Incorporation of Chromia-Doped Fuel Properties in AREVA Approved Methods

ANP-10340NP-A
Revision 0

SUBJECT: FINAL SAFETY EVALUATION FOR FRAMATOME INC. TOPICAL REPORT ANP-10340P, REVISION 0, "INCORPORATION OF CHROMIA-DOPED FUEL PROPERTIES IN AREVA APPROVED METHODS" (CAC NO. MF7707; EPID L-2016-TOP-0004)

FINAL SAFETY EVALUATION BY THE OFFICE OF NUCLEAR REACTOR REGULATION

Figure 5—1 Cr-O Phase Diagram vs O Potential and Conditions for Different Samples Used for Solubility Studies – Black Filled Circles from Reference 5-4, Circles from Reference 5-5 and Squares from Reference 5-1

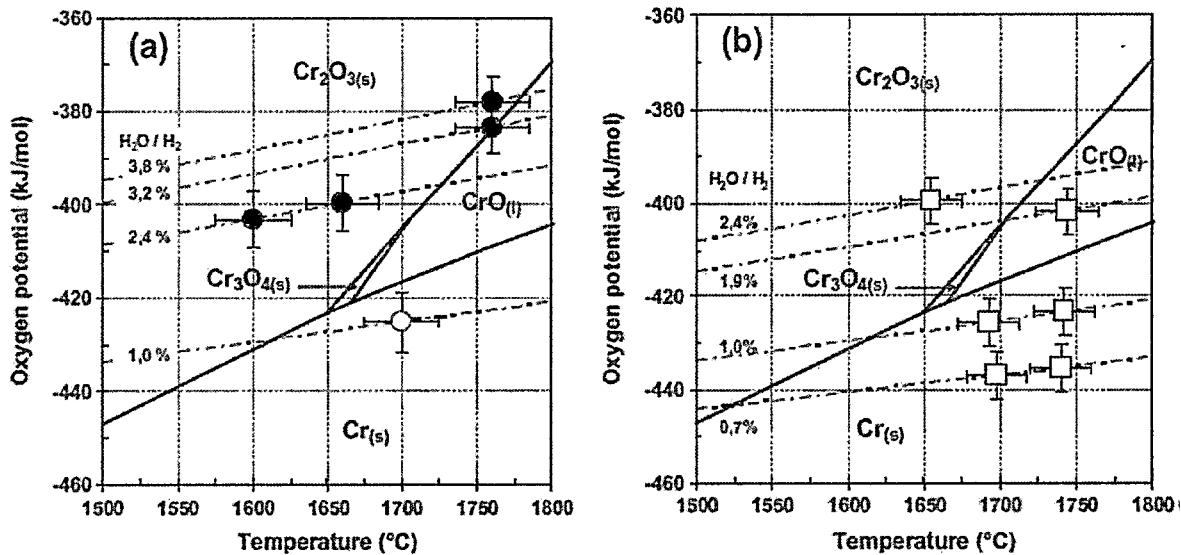
Figure 5-1 illustrates the Cr solubility dependency on O potential, by showing the areas of stability of various Cr solid phases as a family of curves for different temperatures.

Solubility measurements collected in well-defined experimental conditions in the laboratory, which are shown on the right-hand side of Figure 5-1, were performed on hyper-stoichiometric UO_2 pellets, initially doped with Cr_2O_3 and then sintered for a few hours (~4 h) beyond 1700 °C under a controlled moistened atmosphere (pure H_2 or Ar/H_2). The gas moisture was maintained steady throughout the sintering process to ensure the oxygen partial pressure of the system remained constant (which also defines the chemical state of chromium during sintering). The partial pressure of water in the sintering atmosphere was controlled by measuring the dew point of the gas and the resulting oxygen potential was estimated with an empirical formula (Reference 5-1). The Cr in the matrix was determined by EPMA and in preliminary studies indirectly by the effect on grain size (Reference 5-1).

Figure 5—2 Variation of Cr Solubility vs Oxygen Partial Pressure for $T > 1651\text{ C}$ to the Left and $T < 1651\text{ C}$ to the Right (from Reference 5-1)

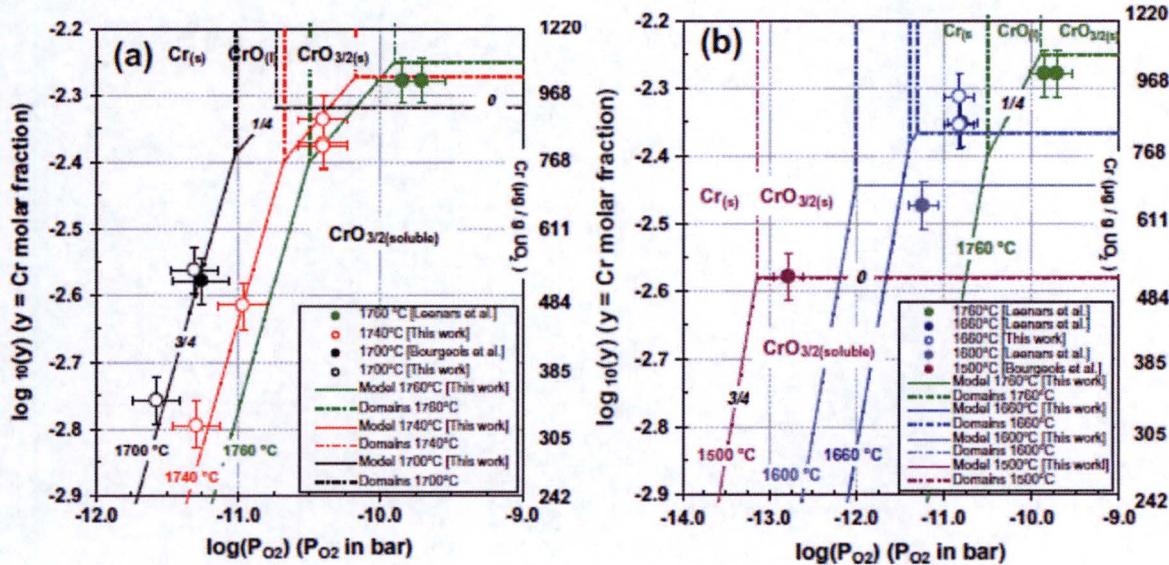
- (i) of slope zero in the Cr_2O_3 stability domain, the solid phase being of same stoichiometry as that of the soluble phase,
- (ii) of slope +1/4 in the liquid CrO stability domain,
- (iii) of slope +3/4 in the metallic Cr stability domain (Figure 5-2).

Figure 5—3 Cr Solubility in UO_2 as Function of Temperature: At Left Insoluble Cr_2O_3 and At Right Insoluble Phases CrO and Cr
(from Reference 5-1)

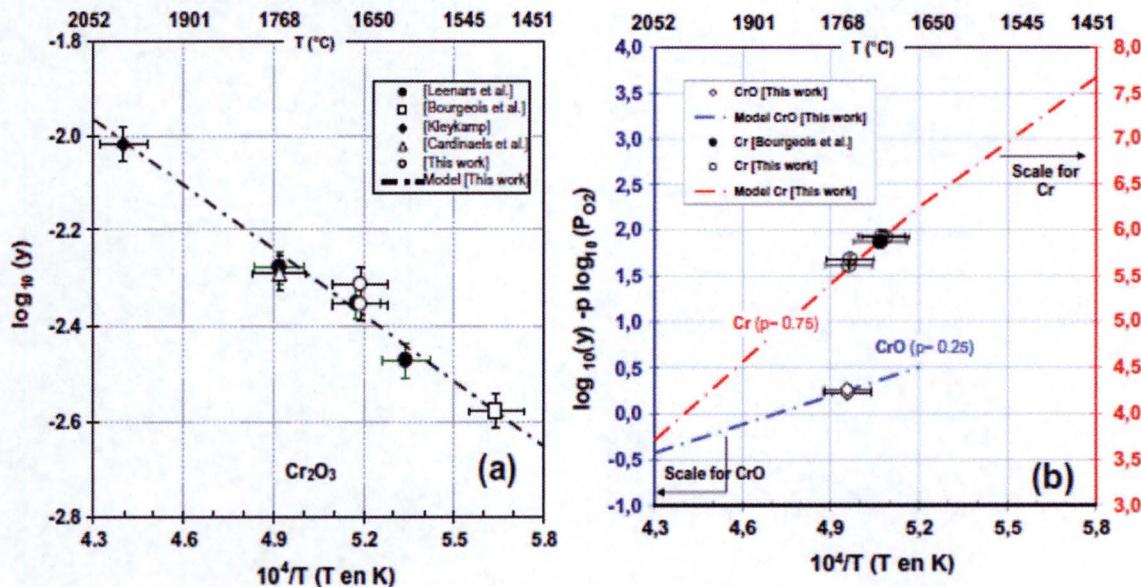
Based on previous data (reviewed in Reference 5-1) and on the recent studies reported in Reference 5-1, the dependency on temperature of Cr solubility in UO_2 can be summarized as follows (illustrated in Figure 5-3):

- (i) the solubility of chromium increases with temperature in the Cr_2O_3 stability range (Figure 5-3, left);
- (ii) the solubility of chromium decreases with temperature in the CrO and Cr stability areas (Figure 5-3, right);
- (iii) the solubility Cr metal in UO_2 is much lower than that of the Cr_2O_3 oxide.

Figure 5—6 Measured and Inferred Radial Cr Profile in a Power Ramped Chromia-Doped Fuel (from Reference 5-2)

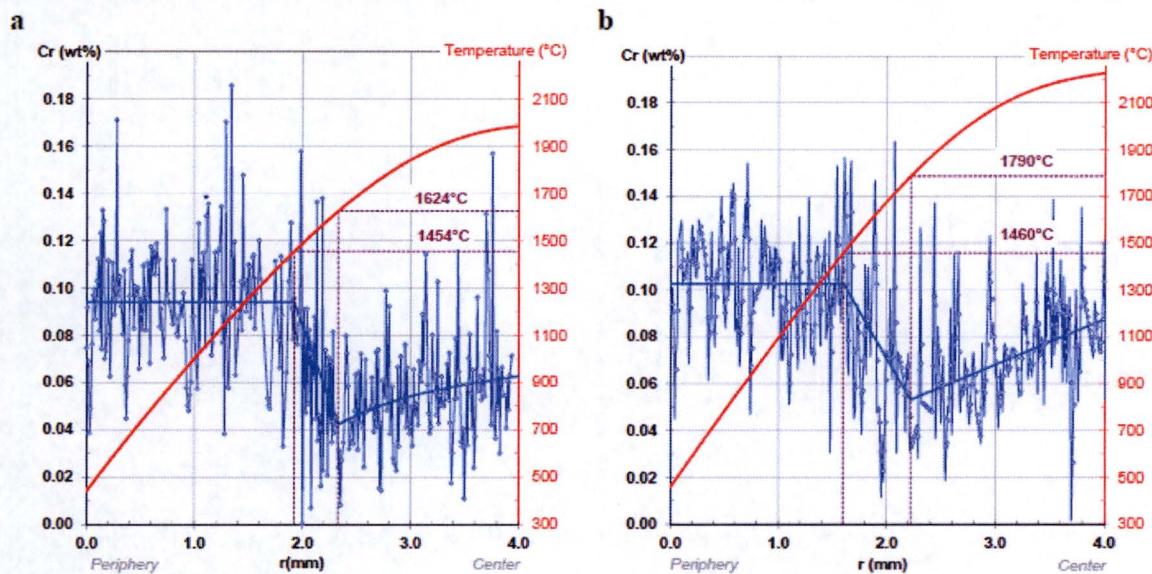
The Cr radial profile after the power ramp is shown in Figure 5-6 based on the hot-cell examination of two ramped fuel rods. The radial profile is the same for the two rods, with a reduction in the center that starts at about the same temperature, although the power and centerline temperature were different.

Figure 5—7 Cr Solubility Variation after a Power Ramp in Two Ramped Rods to Different Terminal Power Levels (from Reference 5-2)

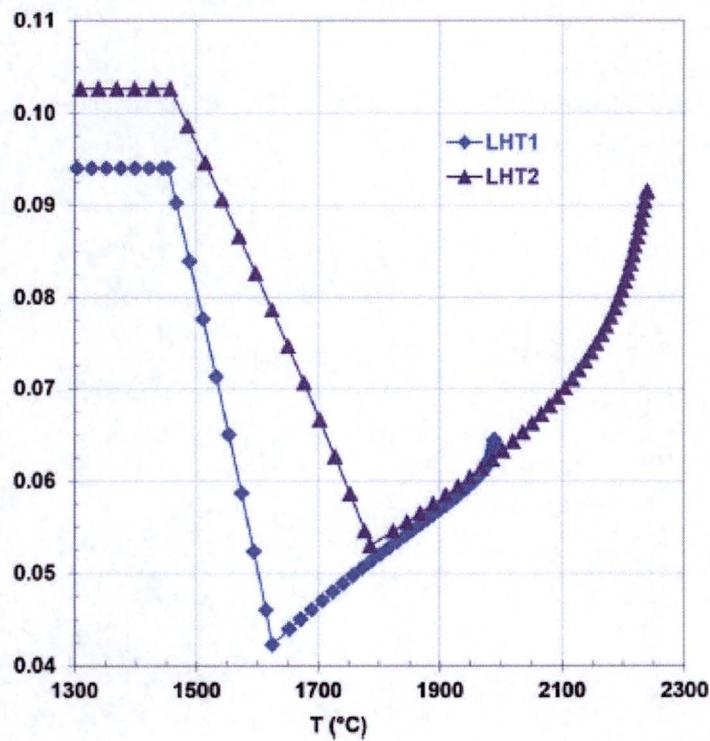
This confirms the previous statement in the introduction that at high temperature (greater than 1500 °C) the state of Cr in terms of oxidation and presence as solute or metallic precipitate is thermodynamically established since the reaction kinetics are very fast. The radial profiles of the two fuel rods overlap over the common temperature range (up to 1460 °C) and the hotter one is a continuous extension of the other cooler rod (shown in Figure 5-7).

Figure 5—8 Derived O Potential during a Power Ramp on Chromia-Doped Fuel Based on Measured Cr Concentrations Shown in Figure 5-6 and 5-7 (Concentrations Shown on the Dash Lines) (from Reference 5-2)

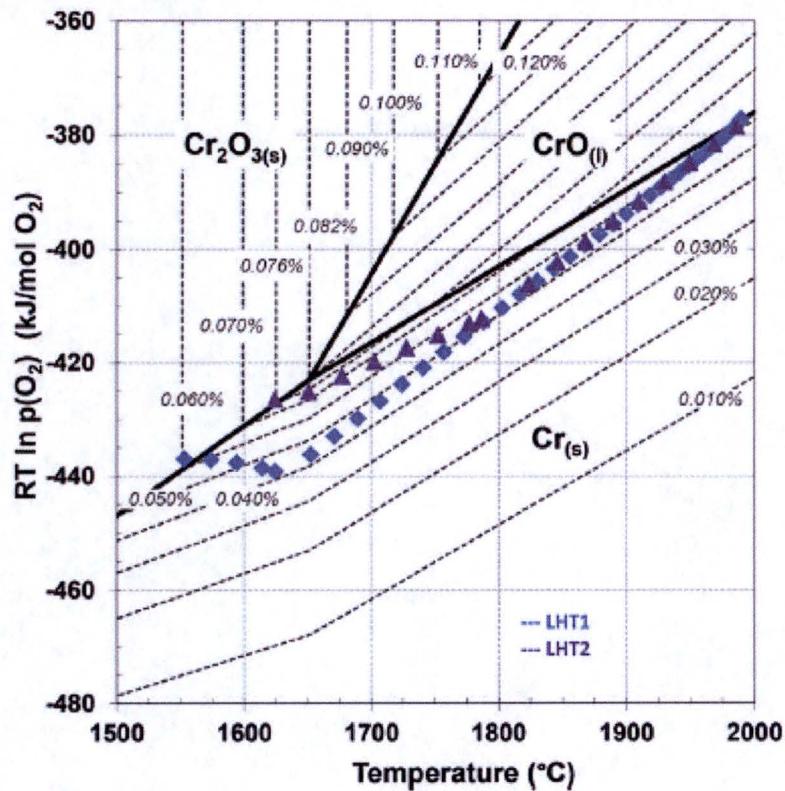
The evolution of Cr in the hot center is further illustrated in Figure 5-8.

Figure 9—2 Fuel Rods in the IFA-716 Rig

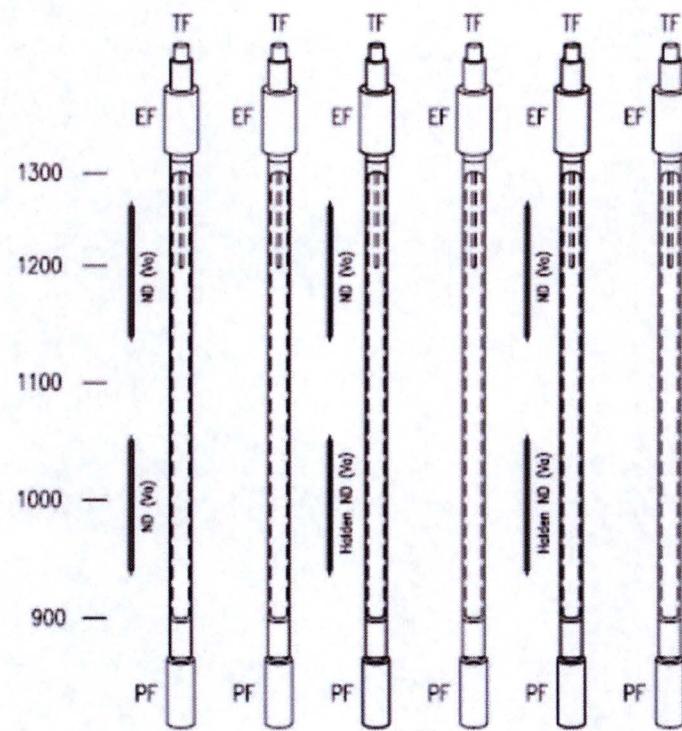
The experimental fuel rods were fabricated at Kjeller from fuel pellets and cladding received from different fuel suppliers. Hollow pellet columns were prepared by drilling a 1.8 mm diameter central hole, in which thermocouples (T/C) were inserted. Bellows pressure transducers (PF in the Figures 9-1 and 9-2) have been attached at one end of the rods with a significant corresponding volume in case of the IFA-677 test, in which a bypass line was needed to attach the pressure transducer (Figure 9-1) and a somewhat smaller transducer volume for IFA-716, in which the PF was attached at the bottom without a bypass line (Figure 9-2).

Figure 9—4 Center Temperature at Bottom T/C for Rod 677-1

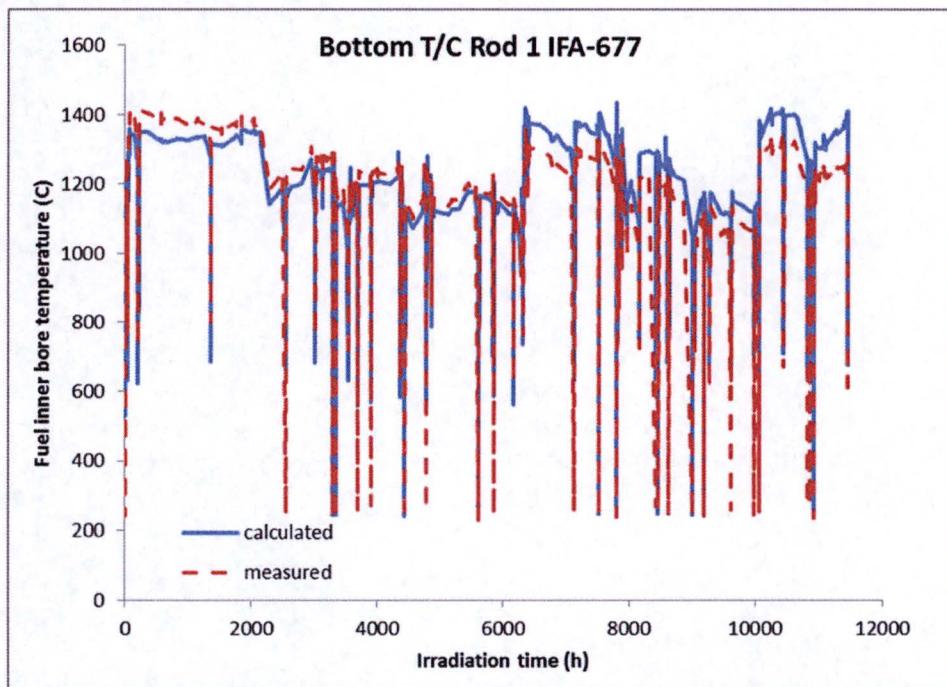
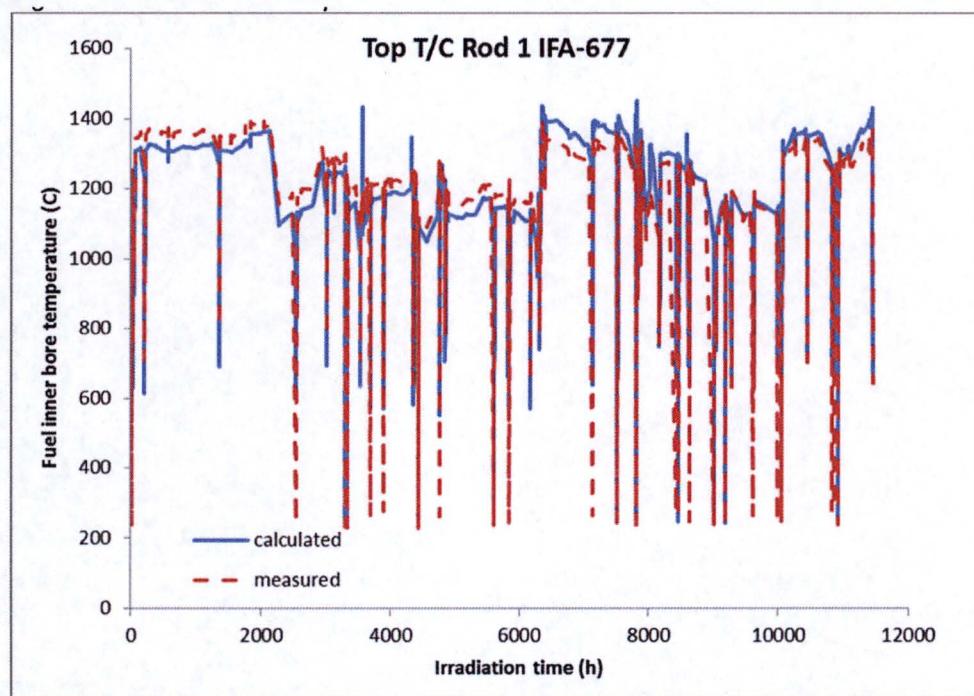
The temperature plots in Figures 9-4 and 9-5 show good agreement overall for both top and bottom T/C locations; it can be observed that a small under prediction for the first half and a small over prediction for the second half of the irradiation history exists. This characteristic is common to most of the modelled rods and is further discussed below.

Figure 9—6 Rod Pressure and FGR for Rod 677-6

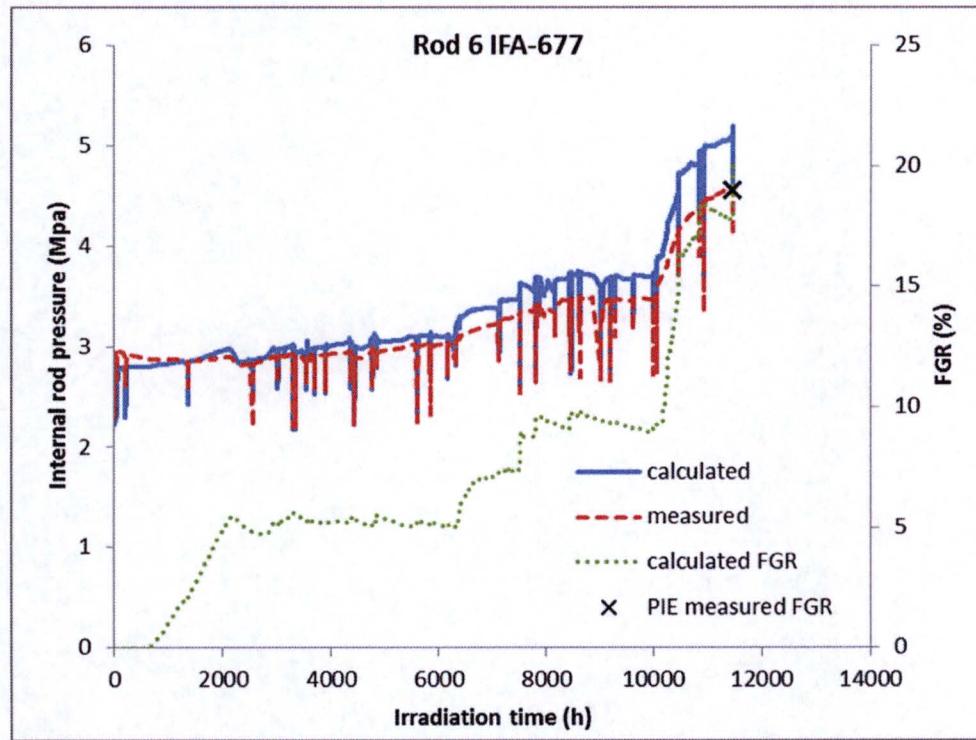
The next two figures show the evolution of rod internal pressure for rods; 677-6 in Figure 9-6 and 677-2 in Figure 9-7. Very good agreement is shown for the rod internal pressure for 677-6, while some over prediction occurred for 677-2; however, the temperature agreement is equally good for the two rods and consistent with the first rod, with a somewhat larger under prediction at the beginning of irradiation for 677-6 (temperature plots in Reference 9-1).

Figure 4-2 Specific Heat Measurement Data at JRC-ITU of Doped and Non-Doped Fuels

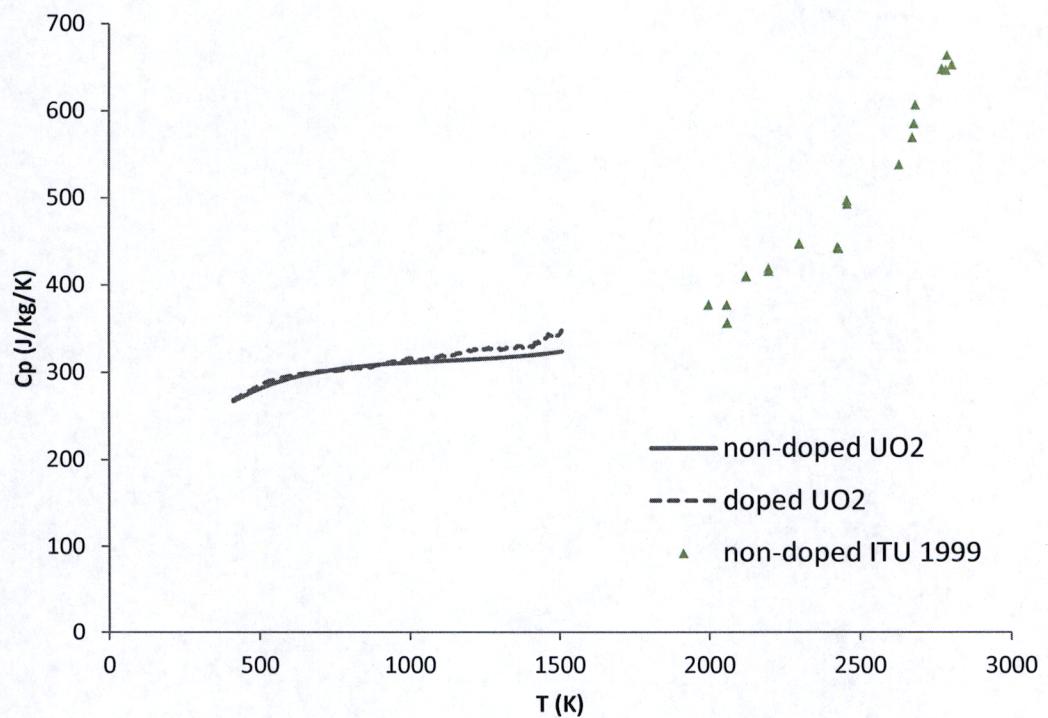
A negligible effect of the chromia additive on the specific heat of UO_2 is observed in Figure 4-2 for the low to medium (about 1500 K) temperature range. The slightly higher specific heat of chromia-doped fuel is in agreement with the law of mixtures and it is appropriate to ignore the negligible increase in specific heat due to chromia additive. The negligible effect of the chromia additive at high temperatures, where data are not available, is justified based on theoretical arguments, which apply over the full temperature domain. The same negligible effect of the chromia additive was also determined for chromia-doped gadolinia fuel.

Figure 7-1 MATPRO and Fink Specific Heat Correlations

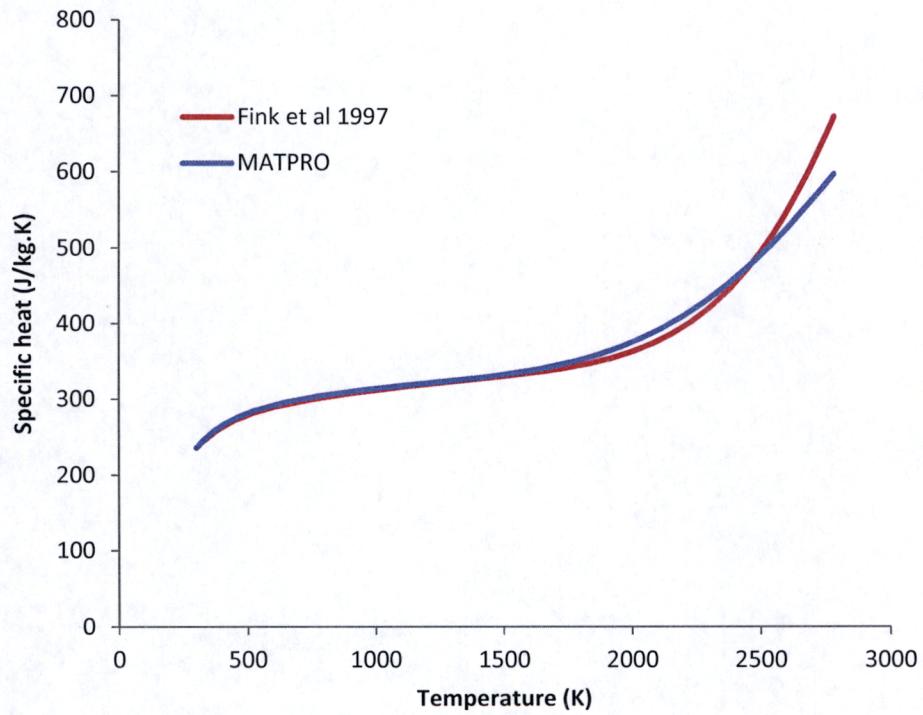
The specific heat model in RODEX4 was taken from the MATPRO library of material properties prepared by INL (Reference 8), which is widely used in the nuclear industry. Another common source for specific heat is the material properties compendium sponsored by IAEA (Reference 21) largely based on the work led by J.K. Fink at ANL (Reference 22). The two specific heat correlations are quite comparable, with about 1% relative difference in the low to medium temperature range and larger differences of up to 4% relative in the high temperature range, as can be observed in Figure 7-1.

Figure 10-1 Ramp Test Data Showing Increased Fuel Failure Threshold for Chromia-Doped Fuel

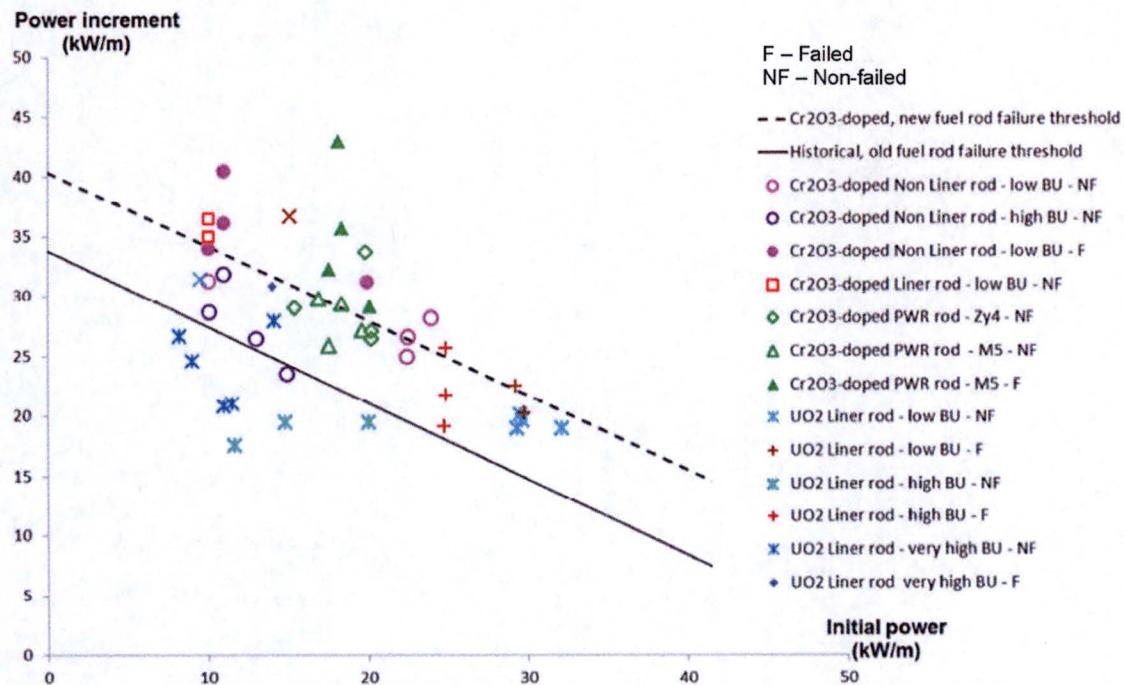
Section 10.2 of ANP-10340P describes ramp testing performed on irradiated chromia-doped UO₂ fuel rod segments. The purpose of these ramp tests was to quantify the PCI-SCC performance of chromia-doped UO₂ fuel and demonstrate it as an alternative to present liner cladding in terms of PCI-SCC protection for BWR applications. Figure 10-1 of ANP-10340P (reproduced below in Figure 3.7-1) provides the Framatome ramp test database as a function of conditioning power versus power increment. Further details were provided in response to RAI 8b (Reference 5).
